1 Products affected

Product Change Notification					Product improvement UH		
owner	creation date	release date	released by	change order no	rev	page	D10-044-735
dislercy	28.04.2020	25.11.2020	bucherfa	2019857	A	1 of 1

Old contact material		New contact material	
Nickel silver, without surface plating		Copper alloy, nickel plated	
Old product label		New product label

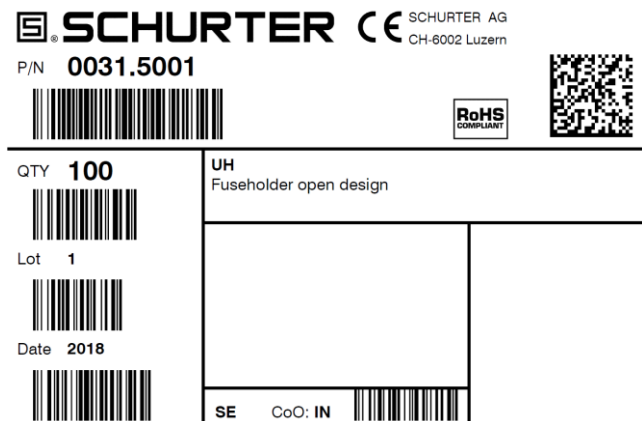
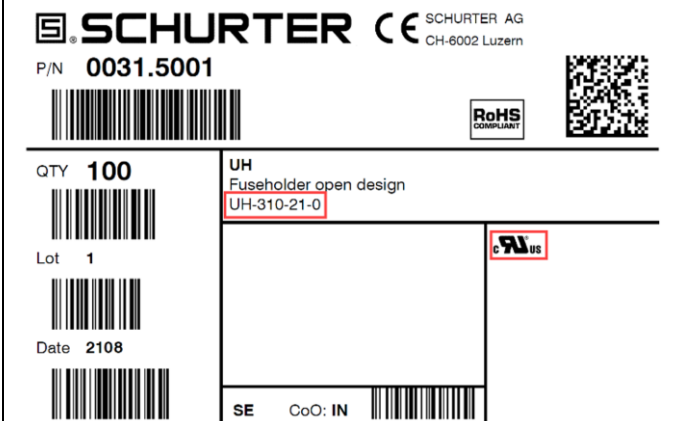
- Change of contact spring material
- Improved electrical contact
- Change of label

- Improved electrical conductivity and contact resistance
- Configuration code and approval mark added on the label

Form	No	No change in form
Fit	No	No change for dimension
Function	Yes	Contact resistance reduced
Manufacturing	No	No change for manufacturing site
Label	Yes	Configuration code and approval mark on the label
Packaging	No	No change in packaging
